TENNESSEE VALLEY AUTHORITY

SUBJECT: GENERAL CONSTRUCTION SPECIFICATION DISTRIBUTION - G-29C (R8) - ADVANCE REVISIONS

Attached are the following advance revisions for filing in your copy of General Construction Specification G-29C (R8):

Figure 8.3 - Alternate Fillet Weld all Around Connection for Members Meeting at an Angle

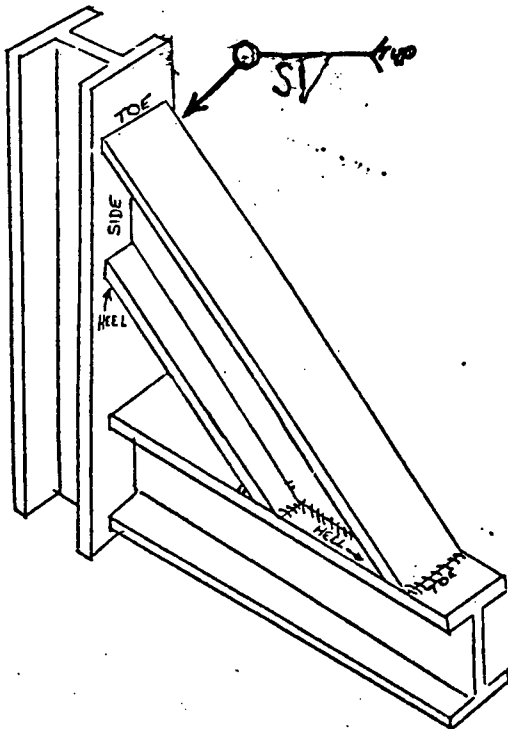
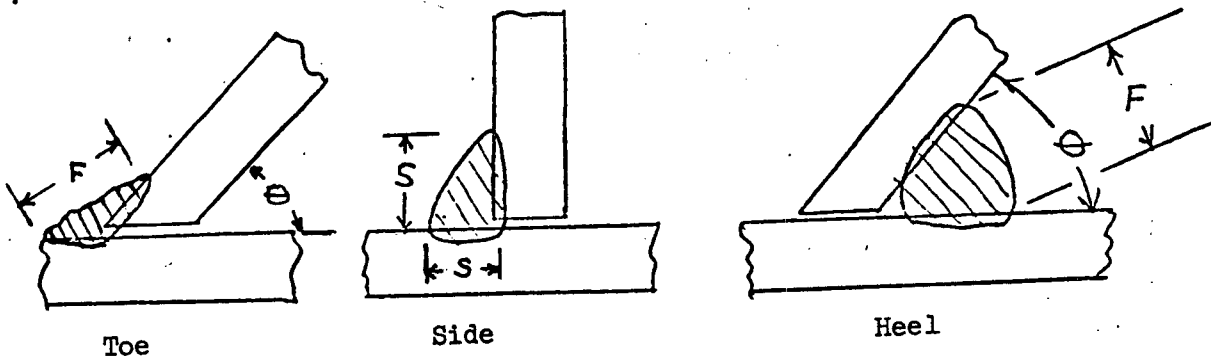
Addendum No. 1 to Process Specification O.C.1.1 (R0) (A.K.A. Addendum No. 1 to P.S.O.C.1.1(a)). Pages 20 and 21 (R1) in Process Specification O.C.1.1 (R0). Remove and destroy pages 20 and 21 of O.C.1.1 (R0).

1. Heel and toe welds to be centered between members to provide approximately equal contact with each.
2. Corners shall provide a smooth transition from the sides to the heel and toe.
